Work Order ID 70189

DESIGN #	DRAWN BY CP	DART AEROSPACE LTD HAWKESBURY, ONTARIO, CANADA	
CHECKED #	APPROVED #	DRAWING NO. D3166	REV. A SHEET 1 OF 1
DATE 02.07.10		TITLE BASKET HOOP	SCALE NTS
A	02.07.10	NEW ISSUE	
A1	04.04.08	38+/-1 WAS 36.0

DRAWING NO. D3166	TITLE BASKET HOOP	REV A1	DART AEROSPACE LTD ENGINEERING ORDER		D.E.O. NO. D3166-A-2	SHEET NO. 1 OF 1	SCALE NTS
DRAWN AJS	CHECKED <i>[Signature]</i>	MFG. APPR. <i>[Signature]</i>	APPROVED <i>[Signature]</i>		DE APPR. <i>[Signature]</i>		
DATE 08.12.11	DATE 08.12.15	DATE 08/12/15	DATE 08/12/16		DATE 08.12.16

D3166-1 BASKET HOOP

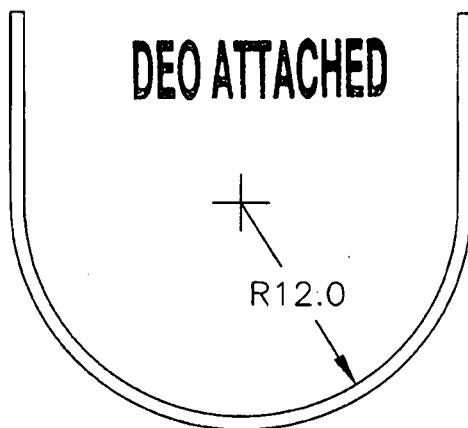
1) MODIFY MATERIAL NOTE FOR D3166-1 AS SHOWN:

WAS:

1) MATERIAL: AISI 304/316 SS SQUARE TUBING,
0.75" x 0.75" x 0.063 WALL, 60.00" LONG
(REF DART SPEC. M304TS0.750W.063)

IS:

1) MATERIAL: AISI 304/316 SS, 3/4 X 3/4 X 0.065 WALL SQUARE TUBING,
60.00" LONG
REF. DART SPEC M304TS0.750W.065

D3166-3 BASKET HOOP

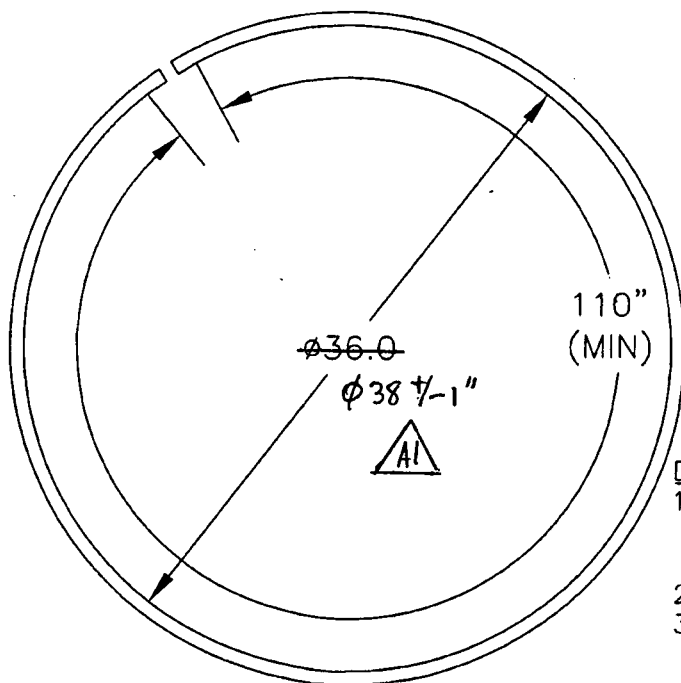
2) MODIFY MATERIAL NOTE FOR D3166-3 AS SHOWN:

WAS:

1) MATERIAL: AISI 304/316 SS SQUARE TUBING,
0.75" x 0.75" x 0.063 WALL, 120.00" LONG
(REF DART SPEC. M304TS0.750W.063)

IS:

1) MATERIAL: AISI 304/316 SS, 3/4 X 3/4 X 0.065 WALL SQUARE TUBING,
120.00" LONG
REF. DART SPEC M304TS0.750W.065
